**HEARING REPORT
TRIG ROAD CORRIDOR UPGRADE
SUPPORTING GROWTH ALLIANCE - NORTH-
WEST
AUCKLAND TRANSPORT AND
WAKA KOTAHI NZ TRANSPORT AGENCY**

A NOTIFIED NOTICE OF REQUIREMENT TO THE AUCKLAND COUNCIL UNITARY PLAN BY AUCKLAND TRANSPORT AND WAKA KOTAHI NZ TRANSPORT AGENCY

Jess Romhany, Policy Planner

Figure 3: AUP maps showing designation boundary in relation to Hilda Griffin Reserve

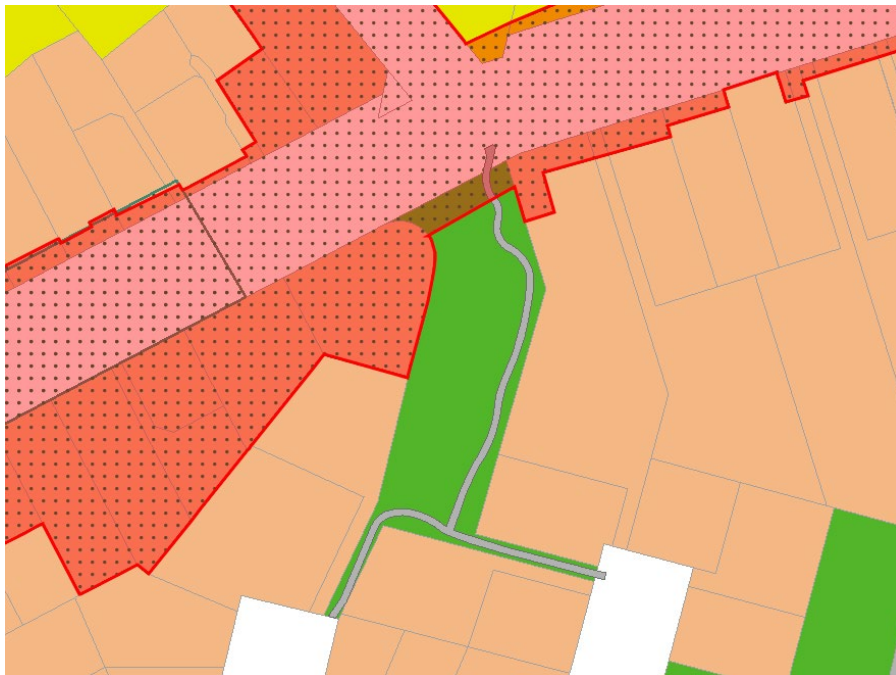
Ms Esterman states that she agrees with the urban design section of the AEE, and supports the route proposed, subject to her recommendation that a pedestrian link be provided back to Hilda Griffin Reserve (located south of Trig Road, across Hobsonville Road).

In relation to this, Ms Esterman states that “...this pedestrian link is required as it is part of a green link that runs from Hobsonville Road to Louise Place, Mona Vale and Midgley Road, connecting the cul de sacs within West Harbour back to Hobsonville Road” (pg. 29). In relation to this matter, she further recommends an amendment to Condition 9 (ULDMP) of the NoR, as below:

I agree with Ms Esterman's recommendation regarding the re-establishment of a pedestrian connection back into Hilda Griffin Reserve. I note that the proposed designation boundary does apply to the front part of Hilda Griffin Reserve and includes a section of existing path that connects with the footpath (as shown in Figure 3 above).

Figure 4: TRCU NoR in relation to catchment and hydrology features, as shown in the AUP maps.

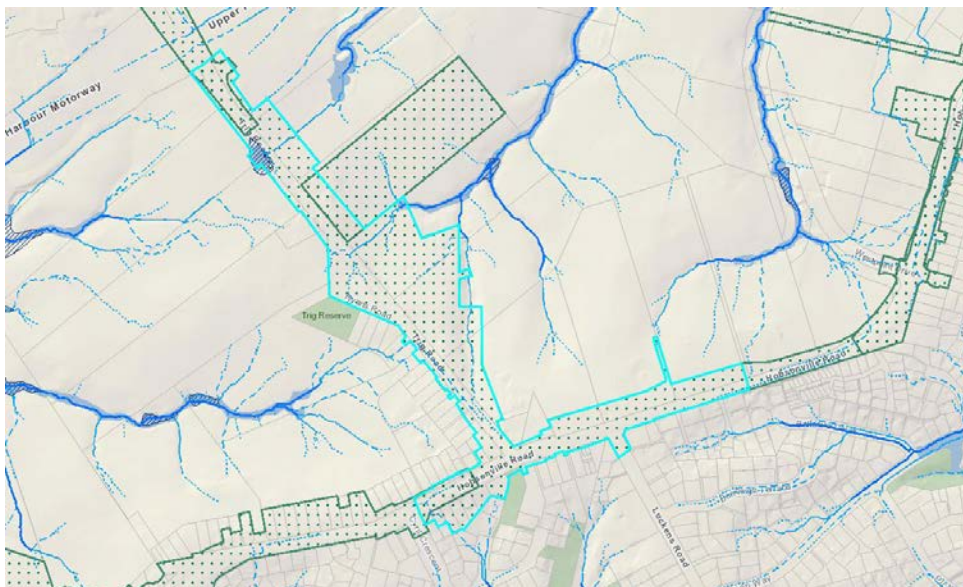
The ASE notes that the Trig Road Corridor is predominantly located on a ridgeline, with surrounding areas falling away from the road. It further notes that there are two flood prone areas along Trig Road, at localised low points. In relation to this, the requiring authority states that "...existing drainage crossings will be upgraded as part of the Project, to better cater for these low-lying areas and mitigate any extended negative effects of flooding these areas might have on future urban development as a result of the road widening" (ASE, pg. 19).

Given the topography of the land and the location of flood plain and flood prone areas, the requiring authority states that the risk of flooding within Trig Road and surrounding catchments is low. Flooding effects are proposed to be managed via Condition 10 of the NoR, which details how the project shall be designed to achieve the specified flood risk outcomes listed in (i)-(v) of the condition. Upgrading of two existing stormwater culverts and one stormwater pipe which cross beneath Trig Road is also proposed to cater for post-development flows and enhance the drainage of flood prone areas.

Figure 7-2 Change in Noise Level - Do Nothing Vs Mitigation Option 2 - NoR RE1

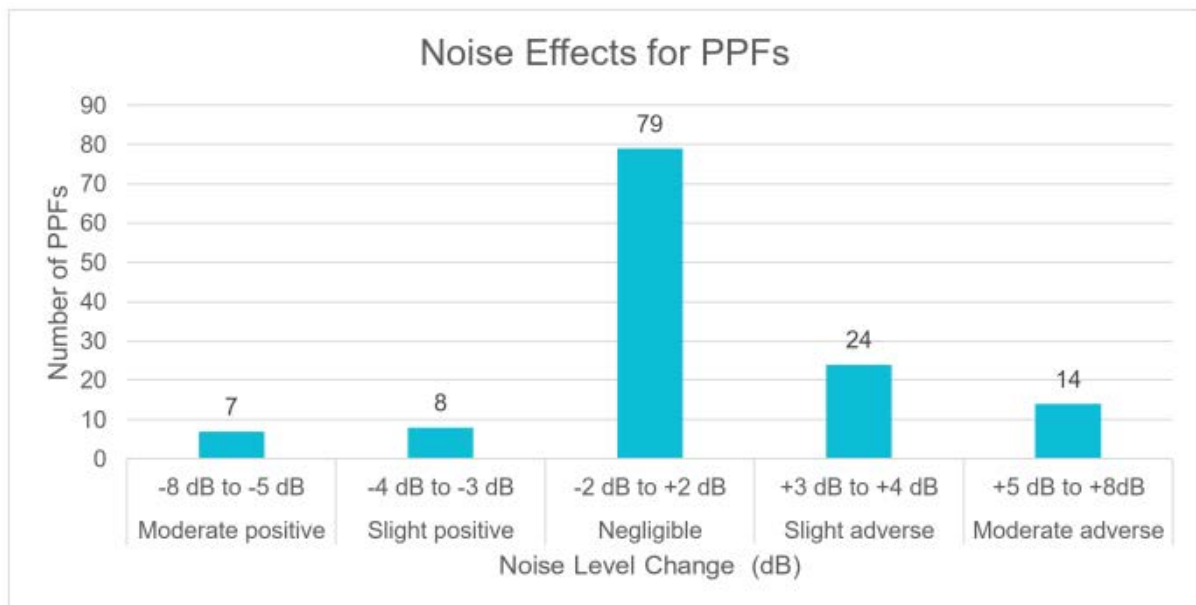
This figure demonstrates that a large number of PPFs will experience a considerable increase in road traffic noise levels if the project is implemented.

Figure 8 NOR RE1 Don Buck Road

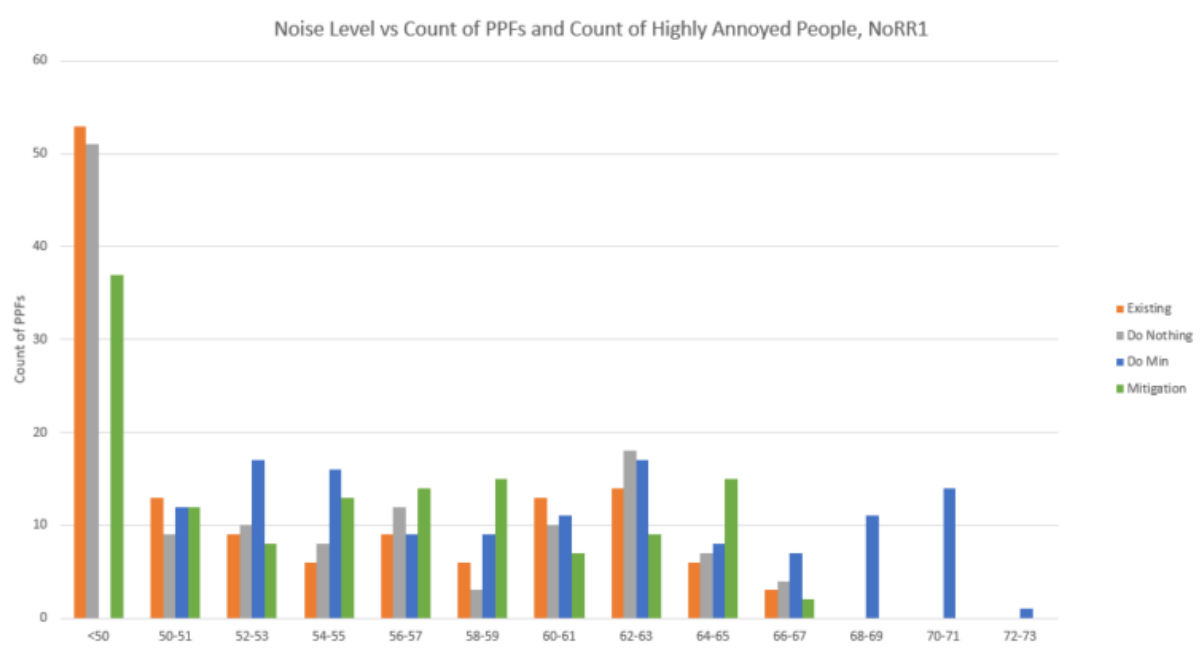
Figure 8 of the s92 Response (for the same stretch of Project) demonstrates that a significant number of PPFs will be exposed to noise levels greater than the WHO interim target of approximately 50dB $L_{Aeq(24hr)}$. I have reproduced this below:

These figures comprise one example of the level of effect that will be experienced by the PPFs surrounding the Projects.

Figure 7: General arrangement plan 3, NoR W1 to show cut batter where existing driveway located for 96 Trig Road

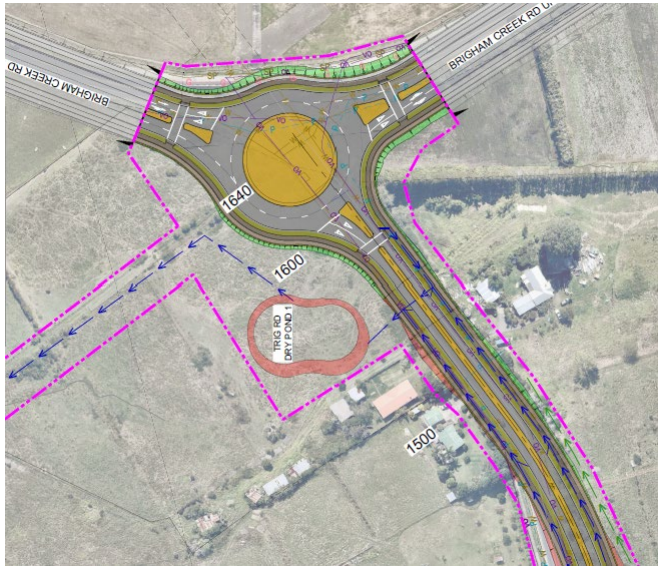
8.16 Submitter 15, owner of 96 Trig Road, is concerned about the extent of property required, including through the middle of the property and loss of access. This site is next to the proposed Brigham Creek Road/Trig Road roundabout. From the general arrangement plans, access appears to be unchanged in this NoR but is shown within the Trig Road NoR (W1) where a batter (cut) will affect access to the existing driveway, see Figure 7. It is recommended the SGA Project Team review NoRs W1 and W3 together to ensure property access to the submitter's site is retained

Figure 16: Separated walking/ cycling pathway outside Boric

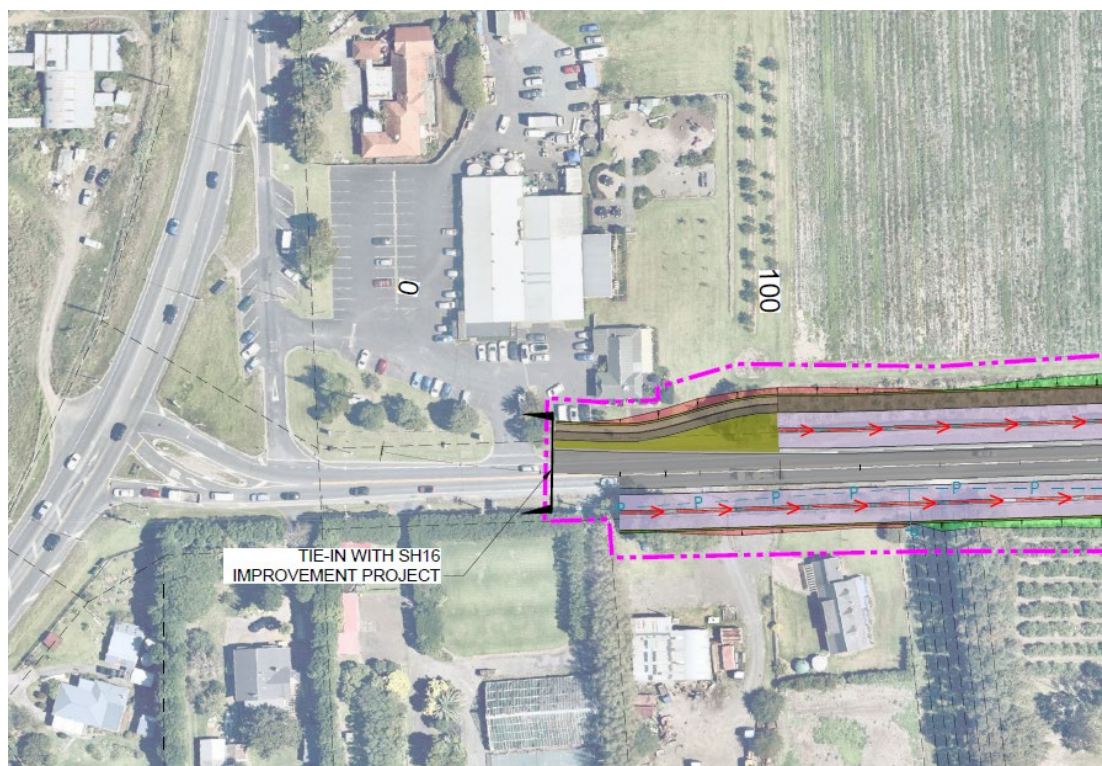
- 13.5 I support the detail shown in the general arrangement plans. However, it is unclear why the area outside Boric Food Market starts as a separated active mode path and then becomes a shared path. From an urban design perspective either shared path or separated modes are acceptable in this location but should be one or the other, see Figure 16 for detail of this area.
